HILLSTONENET Corp 山石网科	
59. THERMAL&HEATSINK	
Title ZXQuicksilver SCM-280ZKA	Rev R001A
Date: Tuesday, May 14, 2019	Sheet 56 of 60

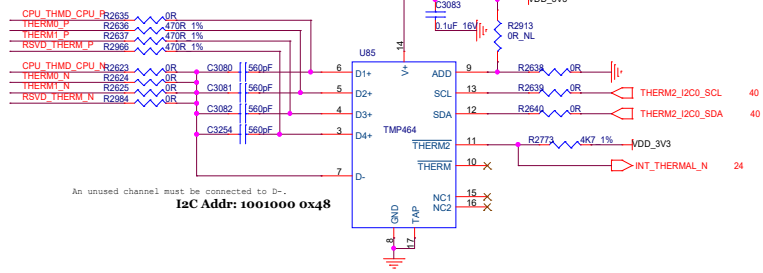
max6699不再备料, 删除U79模块

select one from the two
if TMP464 works well, delete max6699

Heatsink的固定孔孔壁被刷, 封装已经做成plated
